Memorandum to the Appearance Review Commission
Page 1 of 7

RE: Materials for the Appearance Review Commission Meeting
on **Monday, January 19, 2026**

| **ARC 26-04:** 30532-30568 N. Harris Rd

Figure 1: Truck Dock Screening

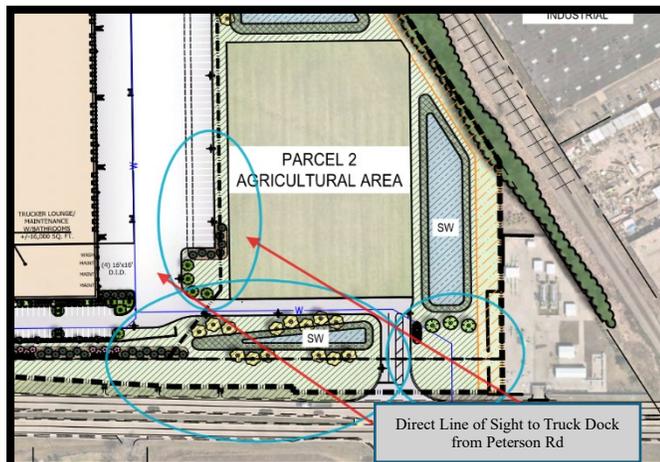
7. The proposed truck docking area on the east portion of the property will be visible from Peterson Road. Staff notes that parking lot screening and perimeter landscaped open space are not proposed within this area for which a variation has been requested. Staff recommends that the Commission consider requesting additional evergreen trees and shrubs to improve screening in lieu of the required parking lot screening and perimeter landscaped open space. This would reduce the direct line of sight to the truck docking area from Peterson Road. Staff also notes that other portions of the site may provide opportunities for additional landscaping. See Figures 1 and 2.
